MECHANICAL/ELECTRICAL ADDENDUM

ME-02

Project: Brantford Animal Shelter

Project No.: VR-23-013

2.12 RECEIVING BAY

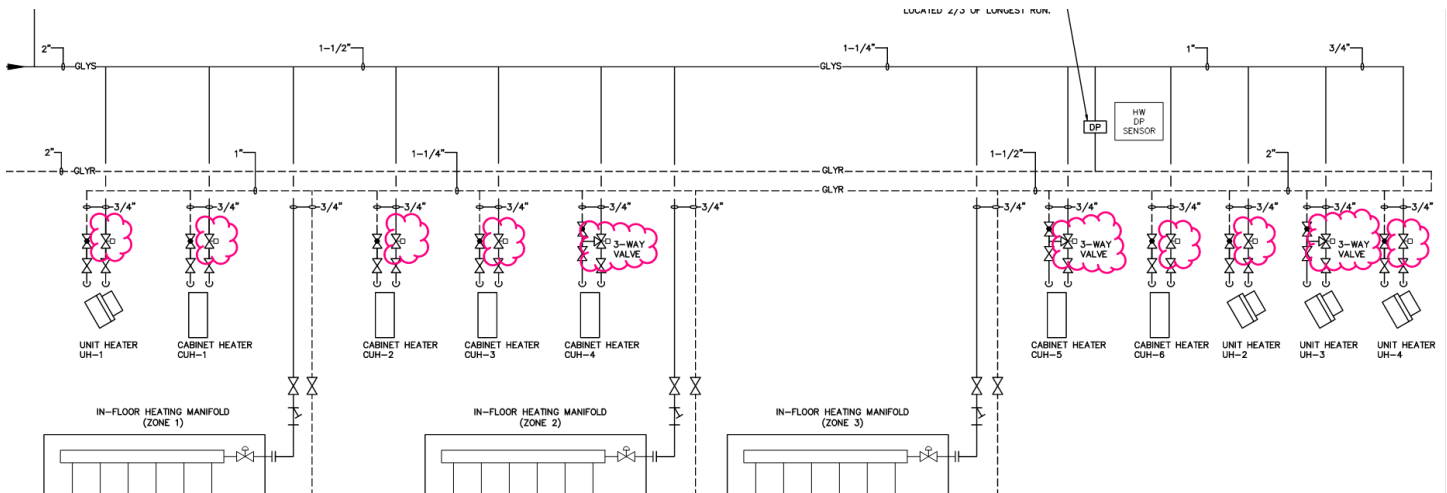
- .1 *The unit heater shall be wired to a line voltage thermostat and controlled to maintain the room temperature set point of 85°F (adj.). On a heating call, unit heater fan shall run.*

- .2 *Exhaust fan shall be interlocked with fresh air intake. System shall be wired to hazardous gas detection system and operates as emergency purge upon high levels of gas detection.*

- .3 *Nitrous dioxide: if any NO2 sensor or group of sensors detects 0.72 ppm NO2 gas, exhaust fan operates and fresh air damper opens. Alarm indicator light is on until hazardous gas concentration levels are reduced to below set point alarm levels. High level alarm: if hazardous NO2 gas concentrations are not cleared after 30 minutes or NO2 gas concentrations continue to increase to 2 ppm, high alarm indicator lights on the main gas detection control panel and audible alarms are activated. Audible alarm to sound and alarm contacts continue to operate the exhaust fan until hazardous gas concentration levels are reduced to below set point alarm levels.*

- .4 *Carbon monoxide: if any CO sensor or group of sensors detects 25 ppm CO gas, exhaust fan operates and fresh air intake damper opens. Alarm indicator light is on until hazardous gas concentration levels are reduced to below set point alarm levels. High level alarm: if hazardous CO gas concentrations are not cleared after 30 minutes or if any sensor detects a carbon monoxide concentration of 100 ppm gas, high alarm indicator lights on the main gas detection control panel and audible alarms are activated. Audible alarm to sound and alarm contacts continue to operate the exhaust fan until hazardous gas concentration levels are reduced to below set point alarm levels.*

- .5 *Motorized damper and actuator to be supplied and installed by Division 23.*
- .6 *Status points of motorized dampers, fan and hazardous gas detection system are to be wired to BAS.*

- .7 *Alarms shall be generated under the following conditions:*
 - .1 *Fan Failure*
 - .2 *Hazardous gas detection alarm*
